UNITED STATES
CONSUMER PRODUCT SAFETY COMMISSION
4330 EAST WEST HIGHWAY
BETHESDA, MARYLAND 20814

Memorandum

SUBJECT : Comments Regarding **Technical Guidance on Unblockable Drains (July 2009 CPSC Staff Draft)** - Request for Comments Published on the CPSC website on July 15, 2009 - Comments due by August 5, 2009

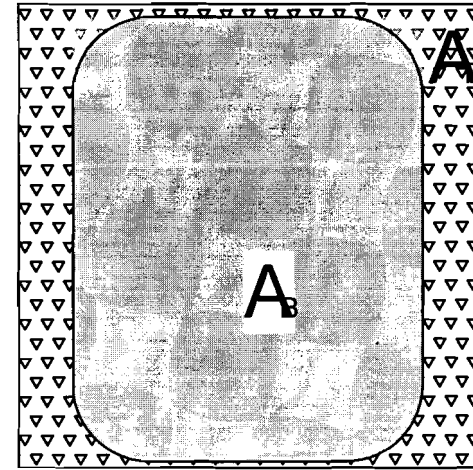
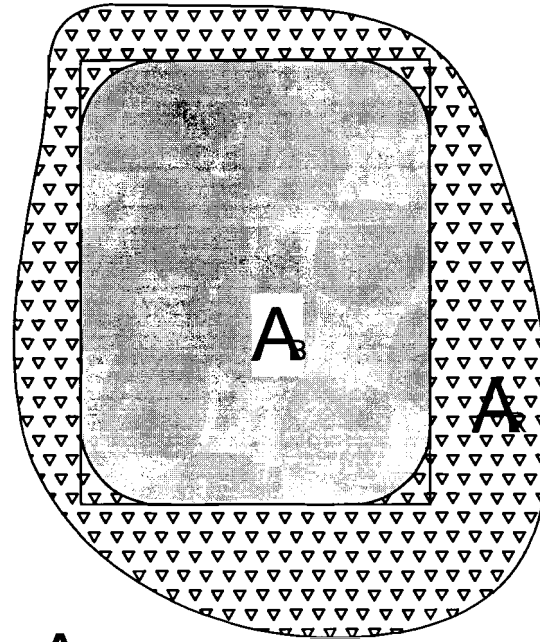
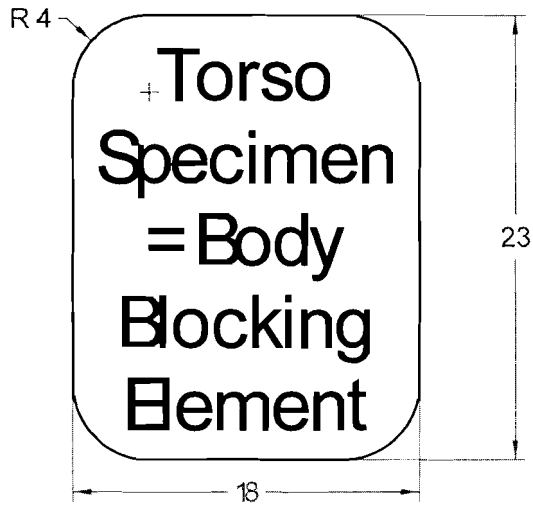
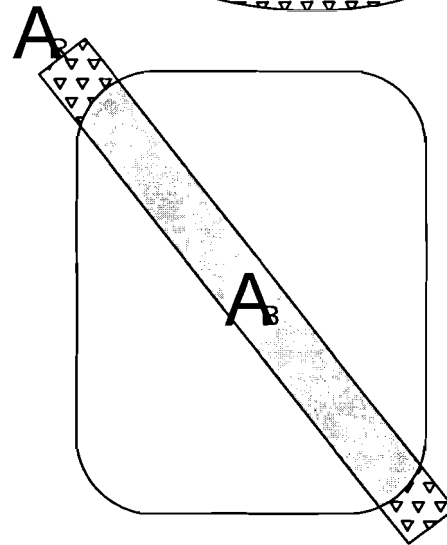
Attached is a series of Cover Grate Formula Examples calculated in accordance with Section 2.3.1.2 of the ANSI/ASME A112.19.8-2008a standard. The calculations show that a cover or outlet with a diagonal of 29.2 inches can, under certain conditions, create a dangerously high entrapping force of up to 6366 pounds for the 99 percentile male torso. As also demonstrated, one might take an existing 18 x 18 outlet and add two "stubby" channels of 3" x 6", making a

Discussion: A hypothetical 18 x 23 perforated area (29.2 inch diagonal) leaves a very small open area remaining when blocked by the 99 percentile man. The allowable flow is only 146 gpm, making such a product commercially impractical. It is less than half the rating of a much smaller Channel. If the more typical flow rating, corresponding to some local codes of 1.5 fps through the open area is used, the entrapping force exceeds three tons on the 99 percentile man, making it dangerous as well. A nominal 24 x 24 is better suited for this product category.

At far right is the specimen blocking a rectangular grate with rectangular perforated area 18 x 23 allowing flow only through small area at corners producing a commercially useless flow rating

Now consider an existing cover with uniformly perforated area 18 x 18 inches with open area of 55%, with (2) 3 x 6 channels added to create diagonal greater than 30".
